Morgan Generation Assets

Written Representation Summary

Figure 1: Location of Morgan Generation Assets Relative to the Millom Field

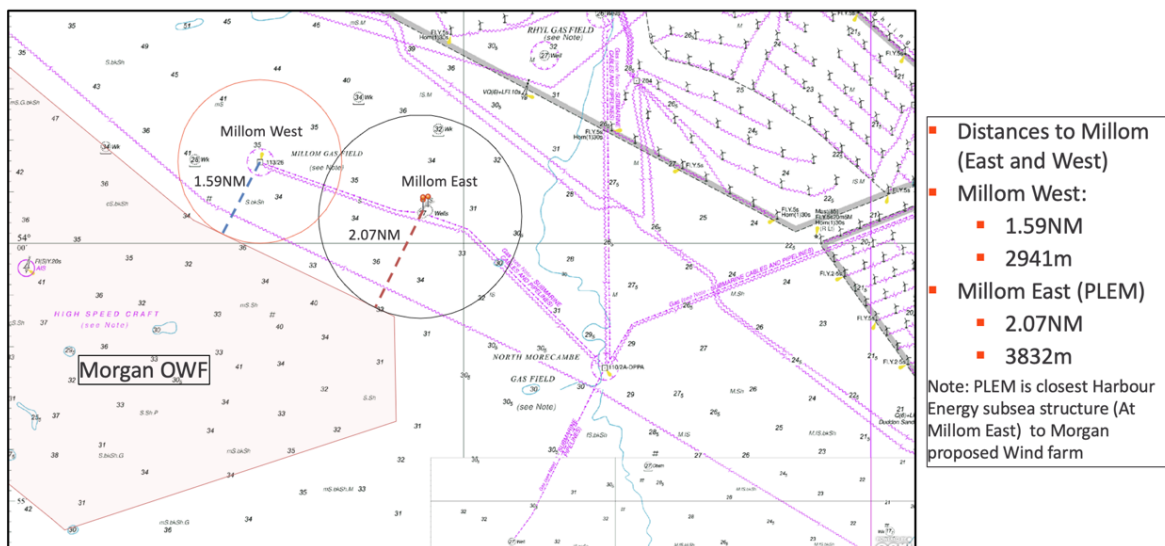
The proposed Morgan Generation Assets are located adjacent to the Millom West Platform and the Millom East subsea facilities, each forming part of the Millom Field owned and operated by Chrysaor Resources (Irish Sea) Limited referred to herein as “Harbour Energy” (See Figure 1). The Millom Field has ceased production, however decommissioning activities are likely to overlap with the construction, and possibly also the operation, of the proposed Morgan Generation Assets.

- A potential mitigation against disruption and economic loss would be for protective provisions to be included in the DCO that ensure that no wind turbines would be constructed with any part of such wind turbine closer than three (3) nautical miles to the Millom East PLEM. This would reduce disruption, however the economic loss would still be in excess of four million GBP (£4,000,000) (excluding any further economic impact of safety mitigations). Compensation could also be considered but would be inefficient when considered on a post-tax basis.

- As set out in Harbour Energy's response to the PEIR, the Millom West platform and Millom East subsea facilities will require marine access corridors free from temporary or permanent surface infrastructure (except as may from time to time be approved by the Millom Operator) as follows:

- a radius of one point eight (1.8) kilometres (1 nautical mile) around the Millom West platform;
 - a one point eight (1.8) kilometres (1 nautical mile) corridor between the Millom West and DPPA platforms; and

- Five hundred (500) metres each side of the Millom West and Millom East pipelines and subsea cables.
- Harbour Energy believes that a condition of granting the Morgan Generation Assets DCO should be a requirement that an agreement (a Cooperation and Co-existence Agreement) is in place between the Applicant and Harbour Energy that ensures that the parties will work together to enable one another's work.
